Change Order Memorandum

Project Name Margate Boulevard Crosswalk and Landscape Improvements
Date 1/6/2026 Change Order No. 2 Project No. 21-0089.00012
Contractor FG Construction

Project Name: Margate-Crosswalk and Landscaping Improvements
Contract No.: MCRA 2024-2
Project No.: 24-669
CO No.: CO002

Scope: Remove existing pavers and curbs. Regrade subgrade and base. Repour curb and install pavers.
Location: Fire Station driveway.

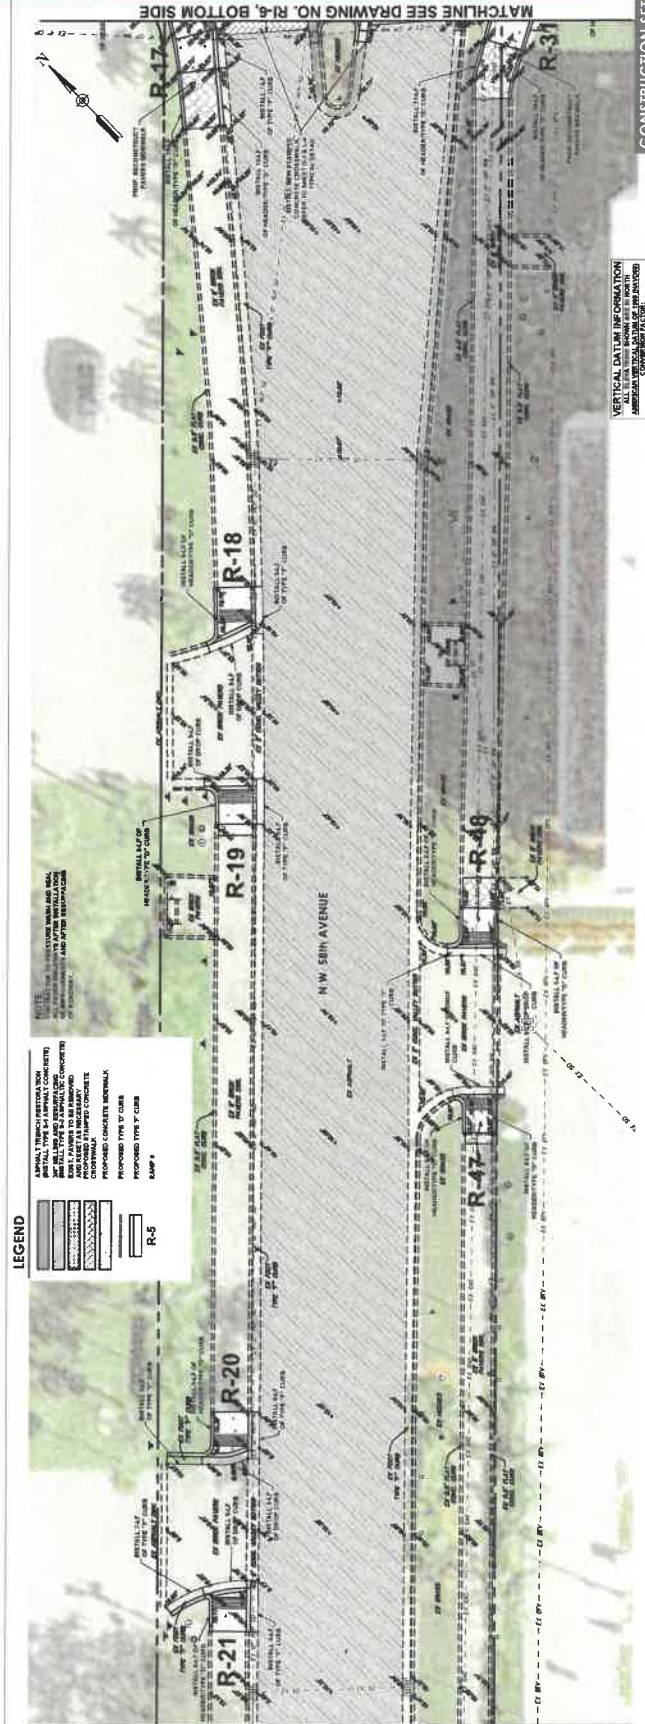
Existing conditions at ramps R-27/28 and its driveway are showing signs of deformation/settlement due to prolonged exposure to heavy traffic loads. Cracks are apparent in the adjacent valley gutter, and the maximum of a 2% cross slope is currently exceeded.

Contractor to remove existing paver driveway between ramps R-27/28. Regrade the subgrade to reflect a 6% cross slope from the valley gutter to the proposed crosswalk, a 2% cross slope across the crosswalk, and an 8% cross slope from the crosswalk up to the header curb of the fire station. Remove and repour header curb.

Additionally, the contractor is to remove and repour the existing valley gutter which is showing signs of distress. Approximately 55 LF of valley gutter, 35 LF of header curb, and 72 SY of pavers to be restored.
